Access Compliance Report

Public Rights-of-Way

Intersection ID: 14672	Main Street: NORFOLK_AV	Cross Street: REMOUNT_RD	Location: S
ADA ID: CC0141872F79	Ramp Type: PerpDiag	Initial Pass/Fail: Fail	Overall Compliance: No
		Severity Score: 37.5

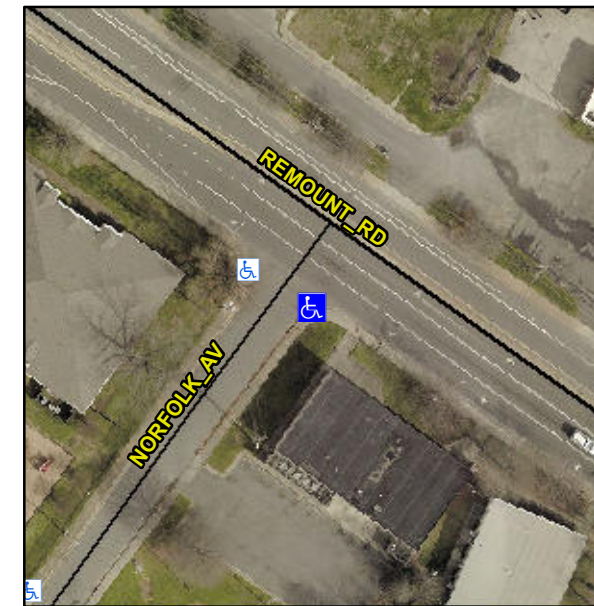
Not Found, R304.2.2, R304.5.3

Compliance	Description	Data	Compliance	Description	Data
N/A	Ramp Length (in)	60.0	No	Ramp Slope (%)	12.1
Yes	Ramp Width (in)	48.0	No	Ramp XSlope (%)	5.7
N/A	Flare Type LT	N/A	N/A	Flare Type RT	N/A
N/A	Flare Slope LT (%)	N/A	N/A	Flare Slope RT (%)	N/A
N/A	Flare Traversable LT?	N/A	N/A	Flare Traversable RT?	N/A
N/A	Landing Length (in)	N/A	N/A	DWS Provided?	N/A
N/A	Landing Width (in)	N/A	N/A	DWS Contrast?	N/A
N/A	Landing Slope (%)	N/A	N/A	DWS Length (in)	N/A
N/A	Landing X Slope (%)	N/A	N/A	DWS Full Width?	N/A
N/A	Landing Curb? (Y/N)	N/A	N/A	DWS Offset (in)	N/A
N/A	Shared Landing?	N/A			
N/A	Gutter Ponding?	Yes	N/A	Gutter Slope (%)	N/A
N/A	Gutter Lip Ht (in)	N/A	N/A	Gutter X Slope (%)	N/A
N/A	Painted X Walk1?	No	N/A	Painted X Walk2?	No
	X Walk 1 Direction	To NE		X Walk 2 Direction	To NW
N/A	X Walk 1 Width (in)	N/A	N/A	X Walk 2 Width (in)	N/A
	X Walk 1 Slope (%)	0.9		X Walk 2 Slope (%)	2.6
	X Walk 1 X Slope (%)	2.6		X Walk 2 X Slope (%)	0.6

Remove & Replace Curb Ramp With Two New Directional Ramps or Equivalent.
